DOH SWPP GWFM Concerns

Critical Drinking Water Risk Evaluation Questions

Groundwater Flow Model Report
Red Hill Bulk Fuel Storage Facility, JBPHH, O'ahu, HI

Modeled Gradient

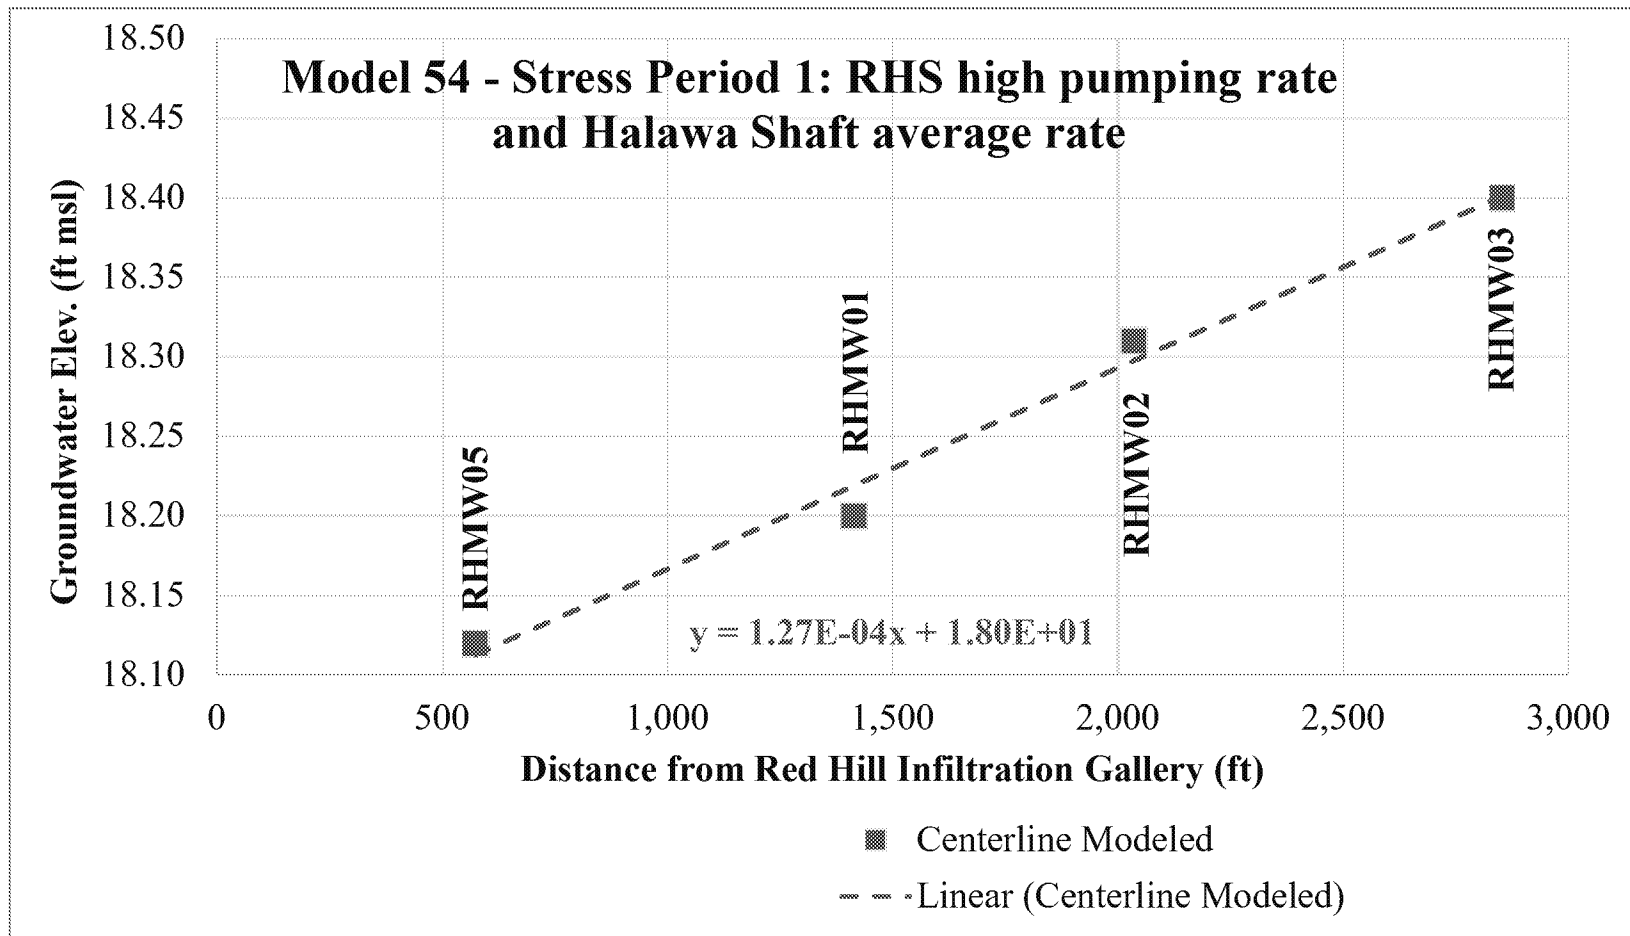
Measured gradient vs modeled gradient

NOVEMBER 2016 SYNOPTIC MONITORING GROUNDWATER GRADIENT FIGURE

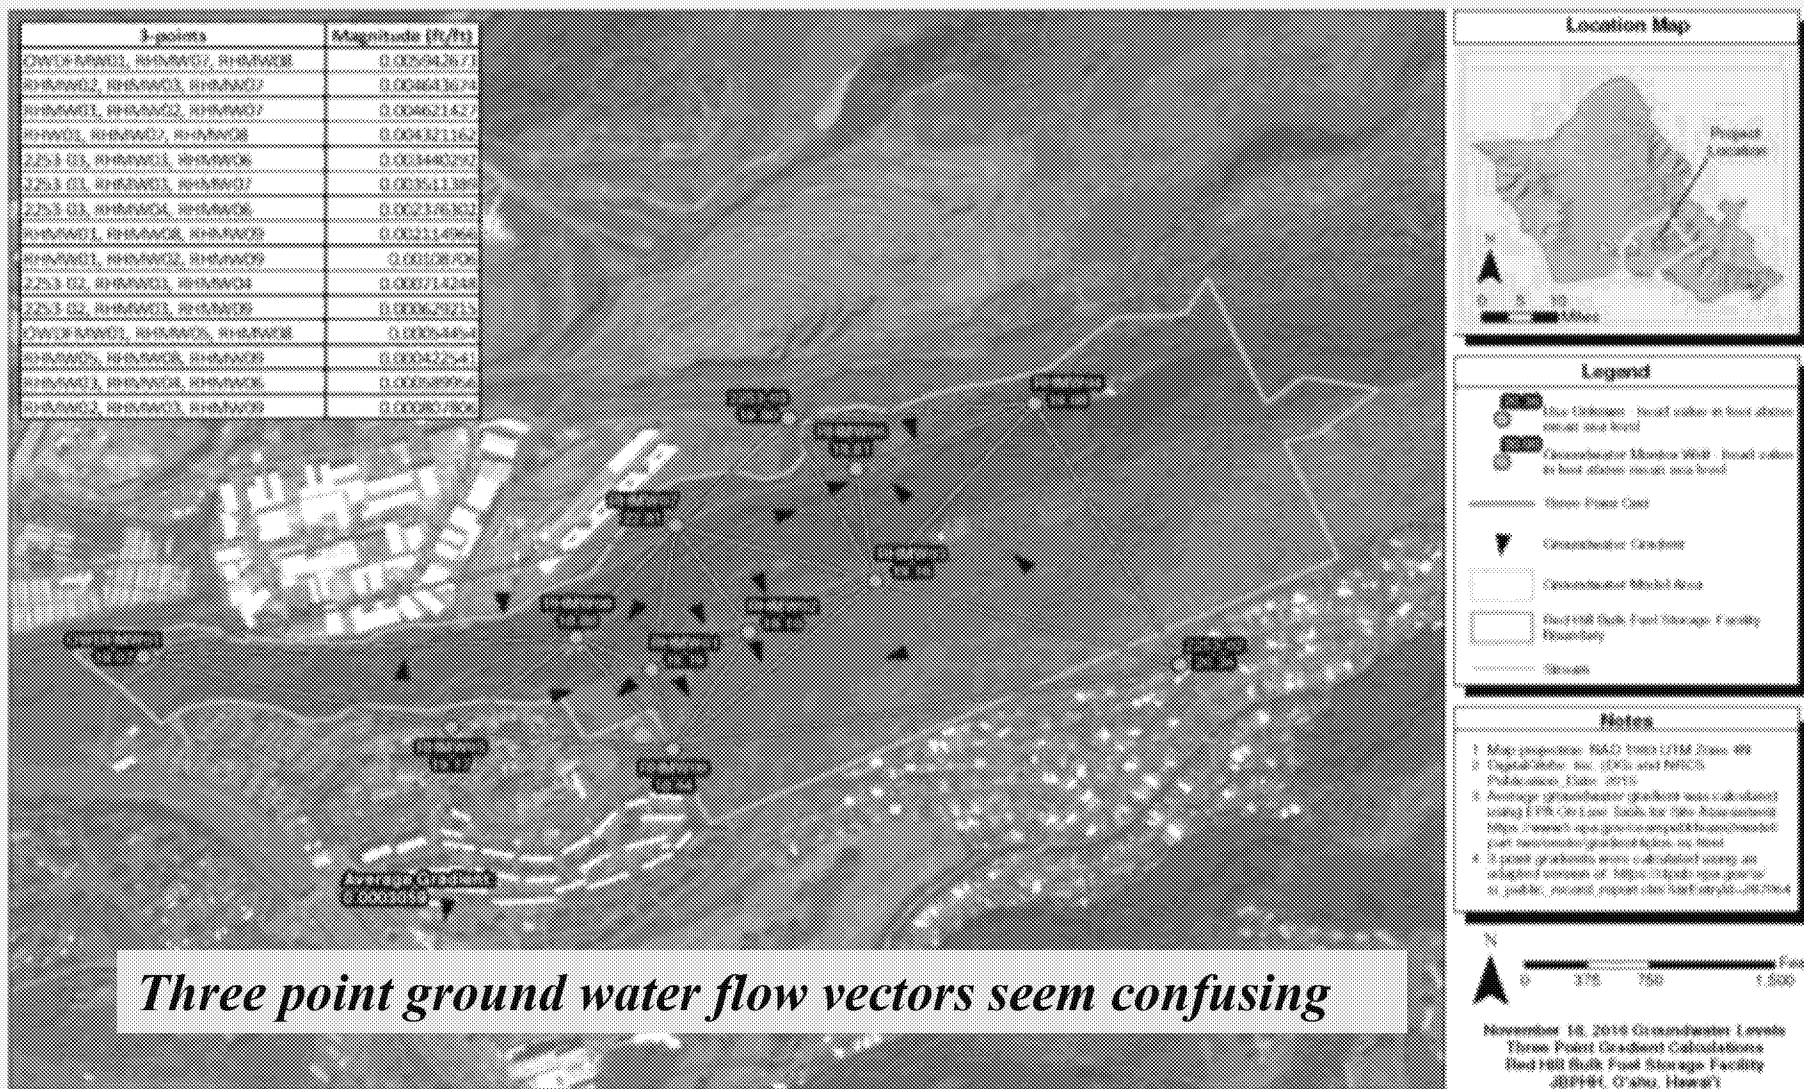
Reliability of GW Elevations

magnitude and direction, which are a primary objective for the model. However, the measurements of absolute water levels or gradients between well pairs may incur errors due to datum measurements and borehole gyroscopic tape corrections for the reasons previously discussed. The spring fluxes at Pearl Harbor Spring at Kalauao and Kalauao Spring were also calibration targets with target values shown in Table 3-2. Weighting on these targets was determined after preliminary PEST simulations such that the flux magnitudes did not overwhelm water level targets in the objective function. Finally, the extraction rates at pumping wells were also included in the PEST multi-objective function to ensure that pumping did not reduce with bottom-hole conditions during calibration.

9. Groundwater Data

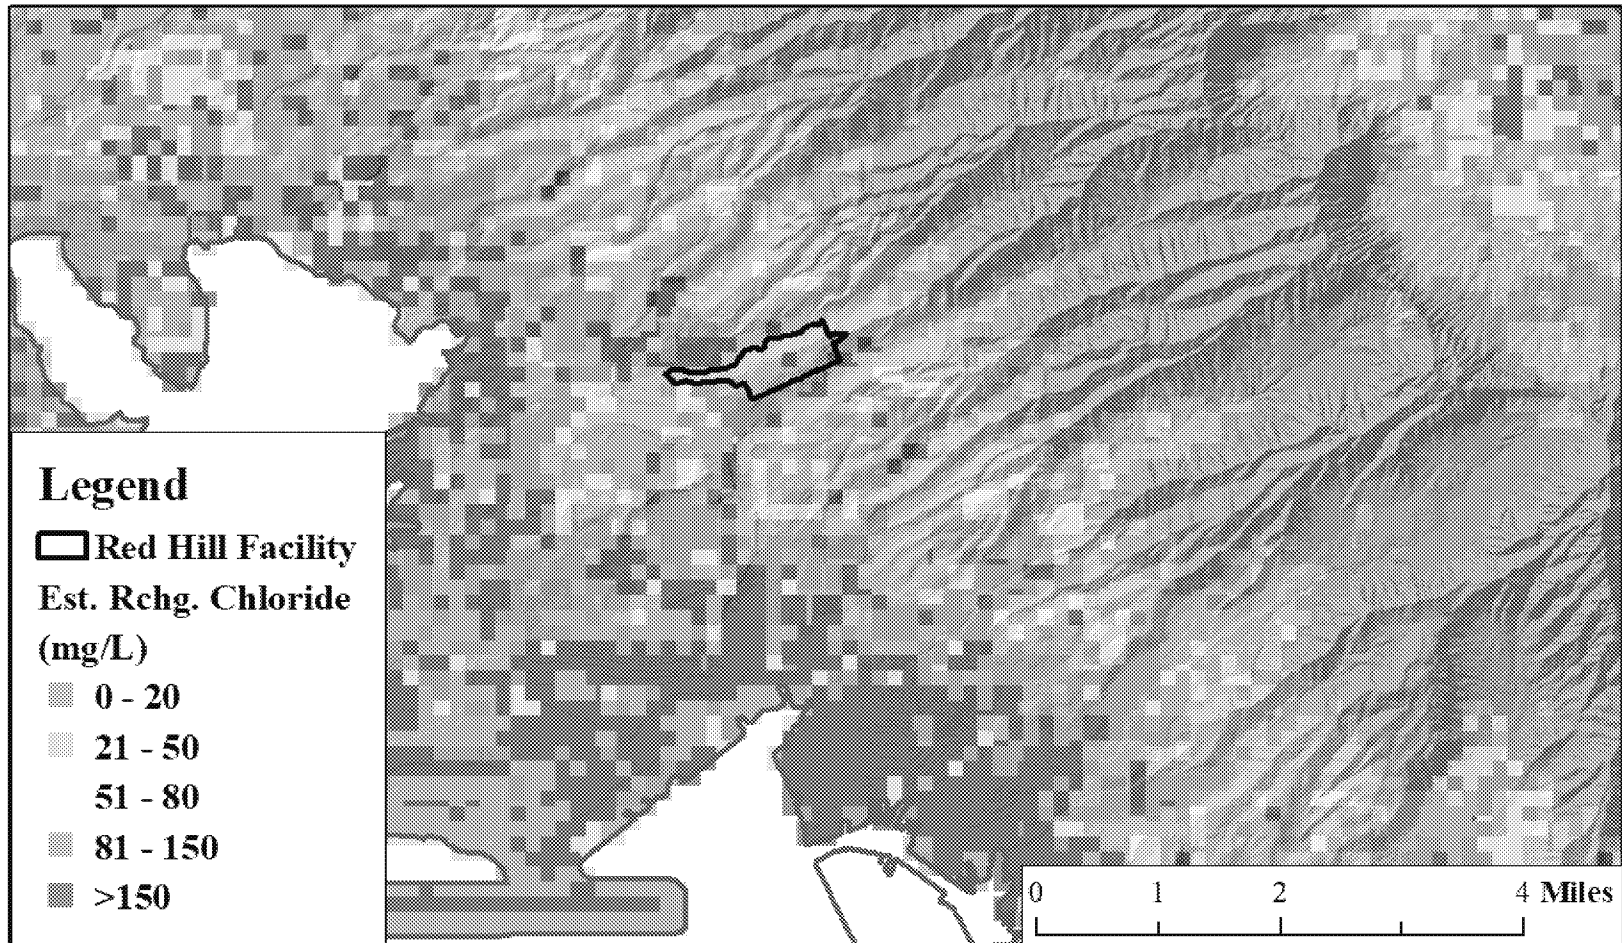
Chemistry shows indication of a poorly mixed system

- Chloride conc. vary from ~40- >1000 mg/L
- Southeast very different from northwest
- Northwest chlorides still highly variable
- A large flux of groundwater down the Red Hill ridge should show better mixing

Estimated Chloride Conc. in Recharge

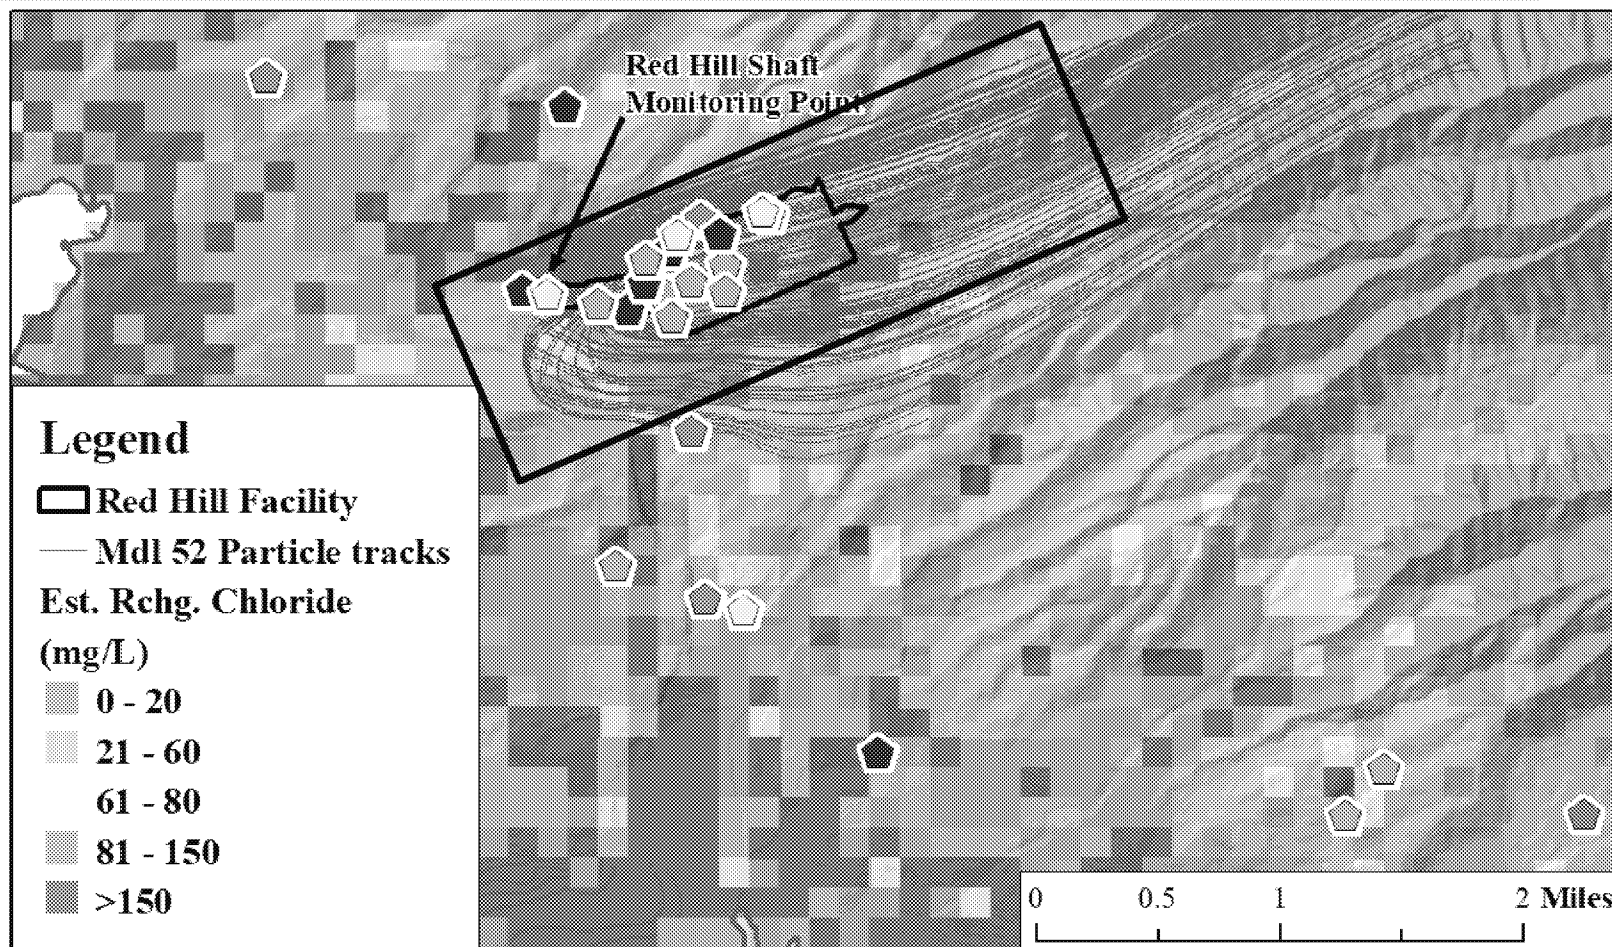
Flow model could be tested using the flow budget utility and representative values of groundwater chloride

Incorporating Geochemistry w/o Doing a Transport Model

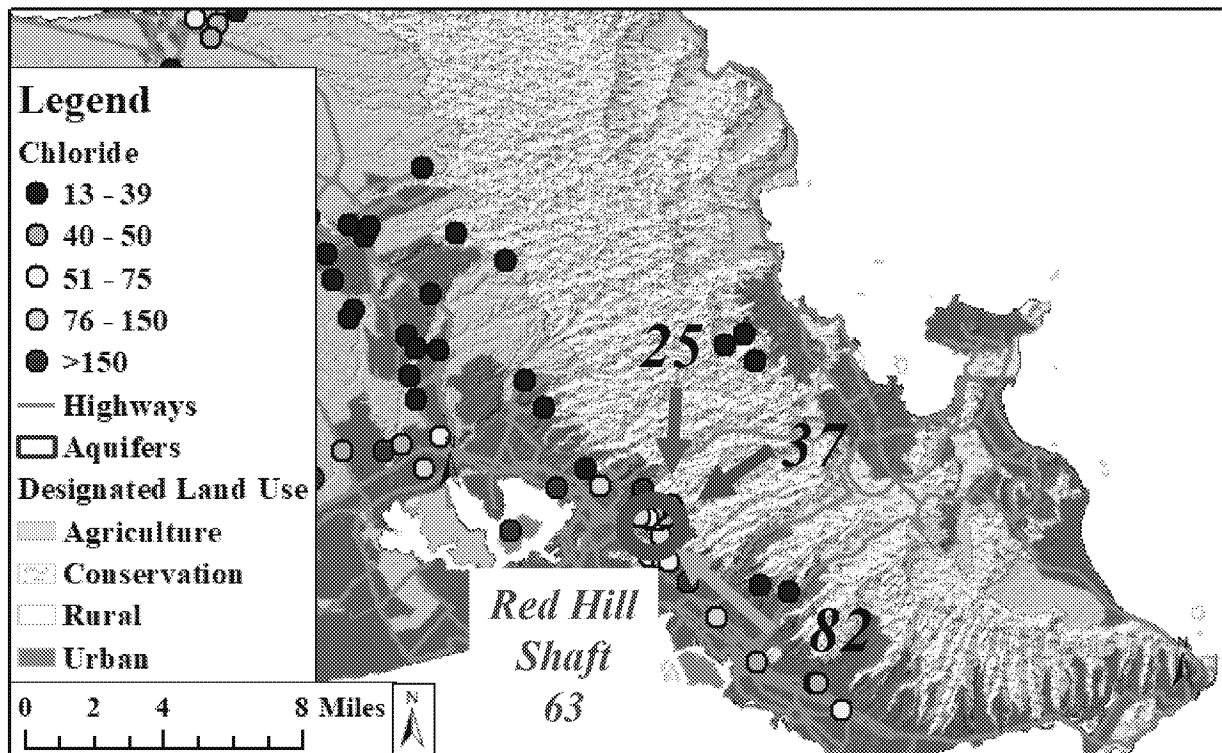
- Mixing Equation
 - $C_{\text{mix}} = (C_1 * Q_1 + C_2 * Q_2 + C_3 * Q_3) / (Q_1 + Q_2 + Q_3)$
- Inflow to Red Hill Shaft
 - Chloride concentration is weighted Cl sum from the source areas

Numbers denote assumed chloride concentration

Westbay Well Chlorides

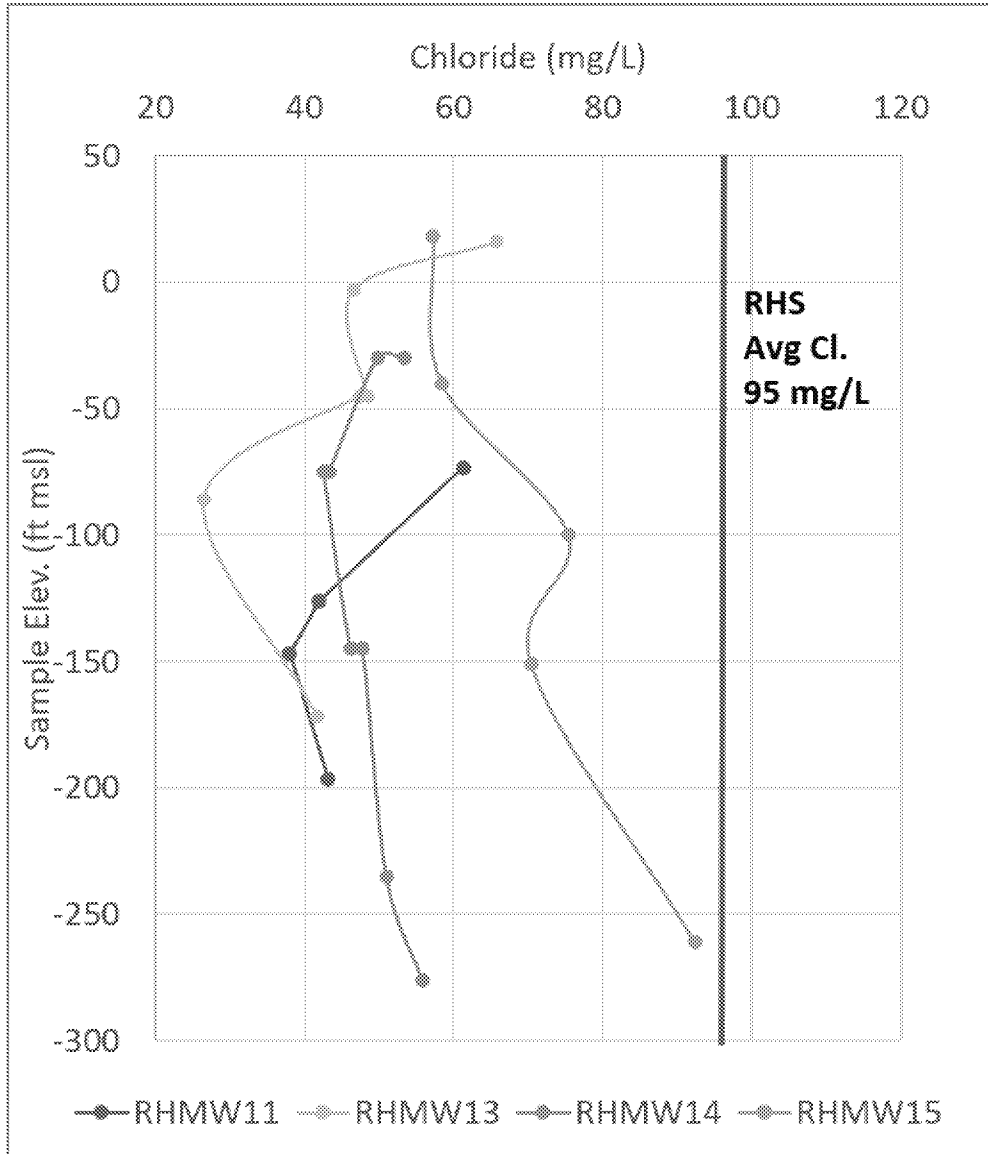
Constrain source area for chloride

- Upslope of the Red Hill Facility all $Cl < RHS\ Cl_{avg}$ of 95 mg/L
- Low Cl in RHMW11, 13, & 14 argue against up flow from HDMW2253 as the source of Cl
- In RHMW15 (near the east end of the RHS infiltration gallery) the chlorides start to approach RHS values only at the deepest sampling port (-260 ft msl)
 - However, water levels indicate a downward gradient

Regional groundwater elevation contours

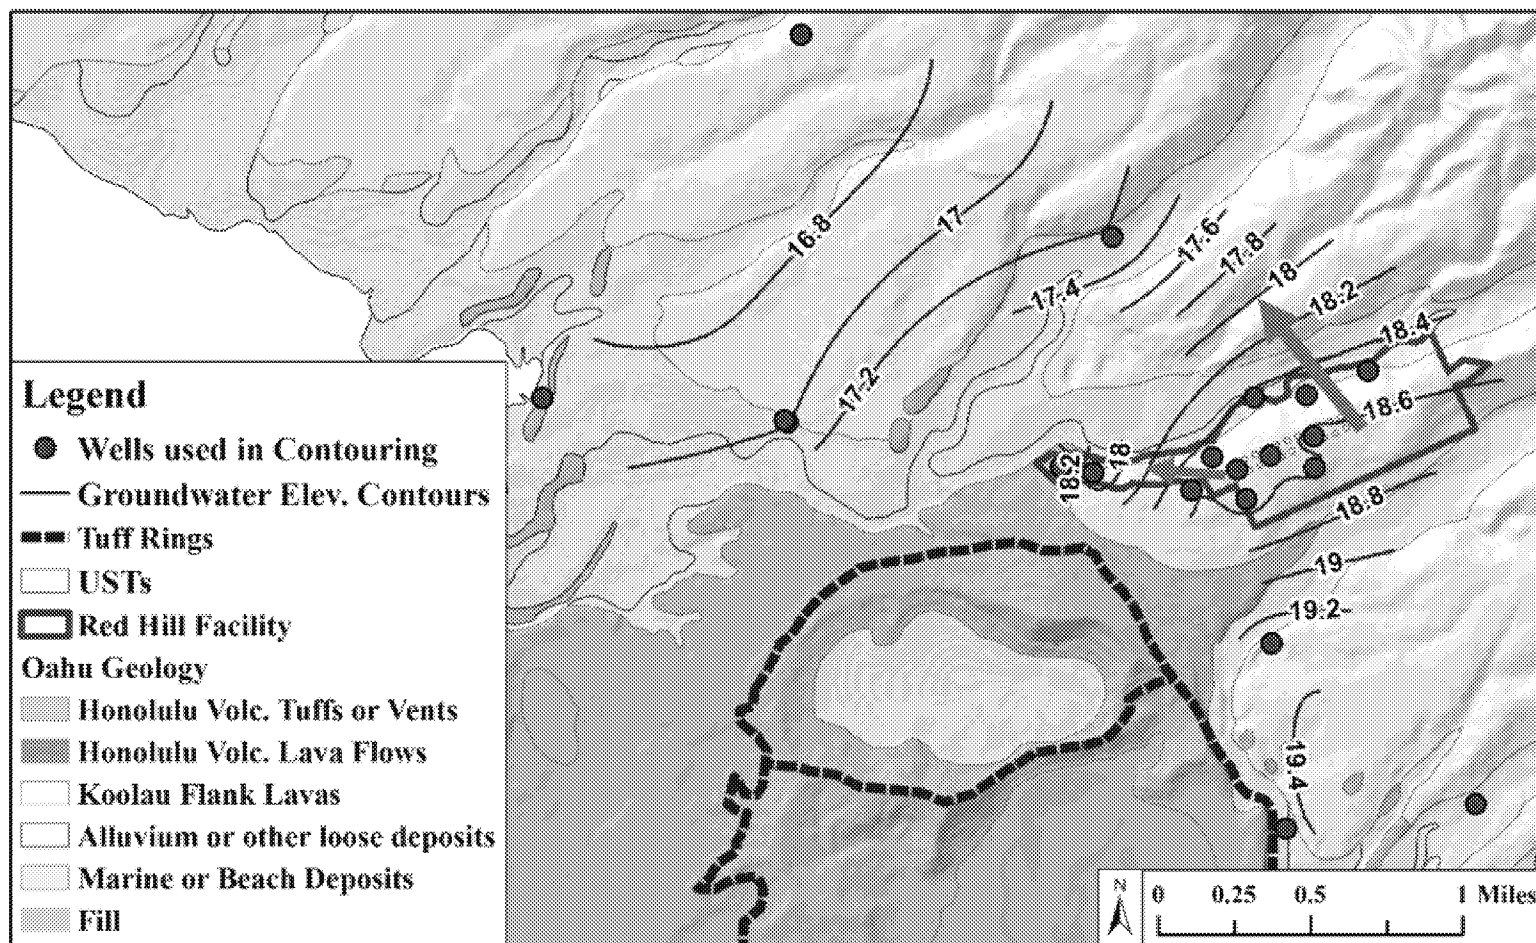
Chloride concentrations could be better explained by the postulated ground water flow directions
